***MODIFICATION REQUEST:
Wollongong Hospital Redevelopment
Crown Street, Wollongong
MP 10_0213 MOD 1***

***Construction of a multi-level car park to
support Wollongong Hospital Redevelopment***

Director-General's
Environmental Assessment Report
Section 75W of the
Environmental Planning and Assessment Act 1979

Figure 4: Proposed car park entry / exit points

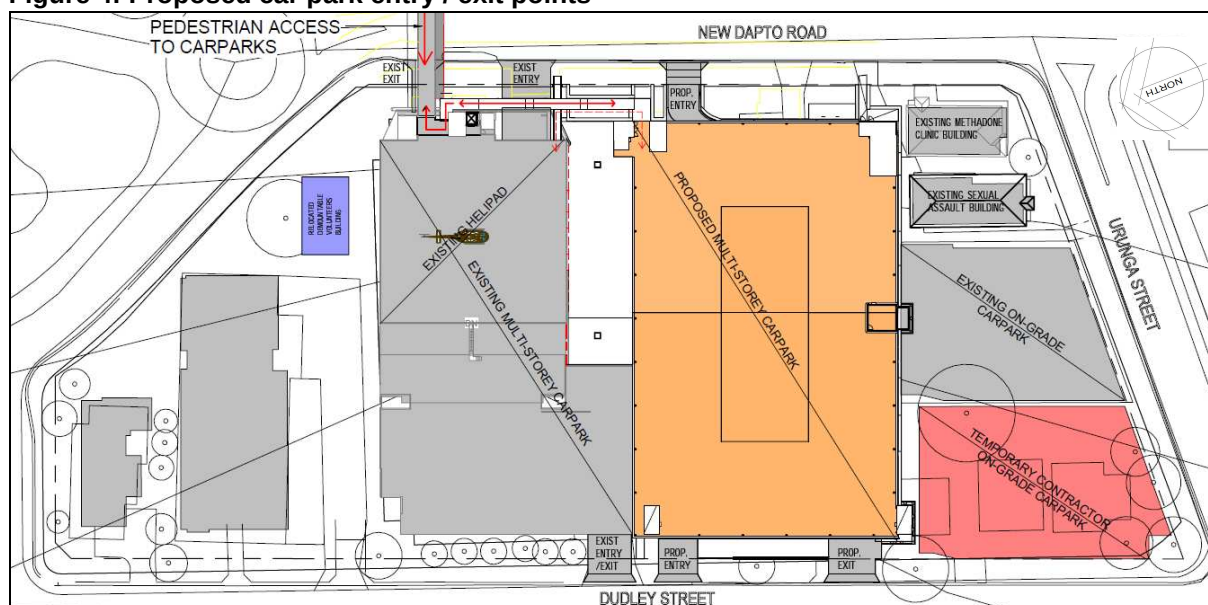
Council and Transport for NSW have queried whether all vehicle access points are required given the potential for pedestrian/vehicle conflict due to the numerous vehicle crossovers.

- even though the car park is designed so that it operates as a single car park, with connections on all levels to the existing car park, the two car parks may operate as standalone car parks to separate staff and visitor parking; and
- the fewer the number of access points, the greater the potential for adverse traffic impacts through additional vehicle queuing.

The department has reviewed the number of vehicle access points and notes that the primary access to the hospital will be via the pedestrian link and therefore pedestrian activity is unlikely to traverse the numerous vehicle access points. The vehicle access points along Dudley Street are similar to those that are currently provided and where there were two vehicle cross over points on New Dapto Road where the cottages are located, there will now be a single cross over. This new vehicle access point would result in a greater number of traffic movements compared to that of the two previous cross overs, however, this access is required to accommodate vehicle queuing requirements on New Dapto Road. Furthermore, due to the locations of the bus stops and station, the vehicle access points would not result in any additional conflict points with public transport users' access to the campus. Accordingly, the department considers the proposed access points acceptable.

Figure 6: Photomontage view of the car park along New Dapto Road with views to the escarpment in the background

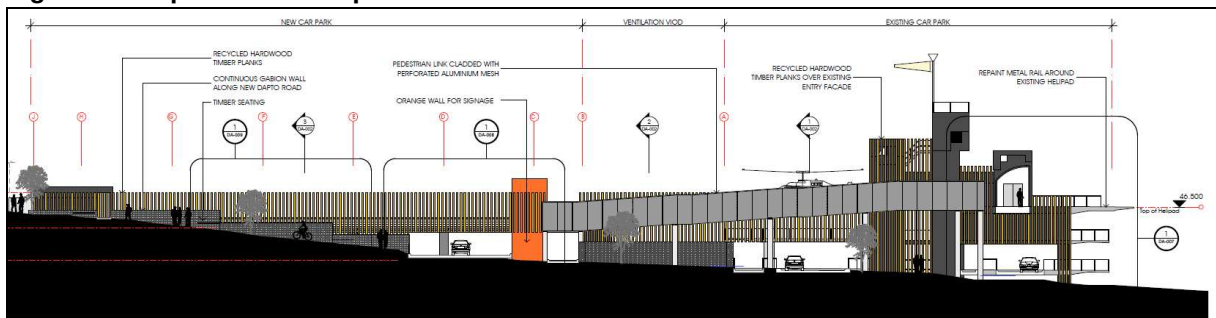
The proposed car park would have minimal view impacts on the views to the west of the mountains from east of the car park as the car park only presents as a predominantly single level development to New Dapto Road and the hospital is situated higher up the slope (see **Figure 6**). Any views from the hospital would be generally unaffected and any views from beyond the hospital would be already impacted by the hospital buildings on the main campus. As the site falls away to the north-west and the proposed scale of the car park is consistent with the existing car park, views impacts on the surrounding area would be minimal as they would either already be lost as a result of the existing car park or the view point would be on higher ground and above the uppermost level of the car park. The department considers the view impacts are minor and satisfactory.
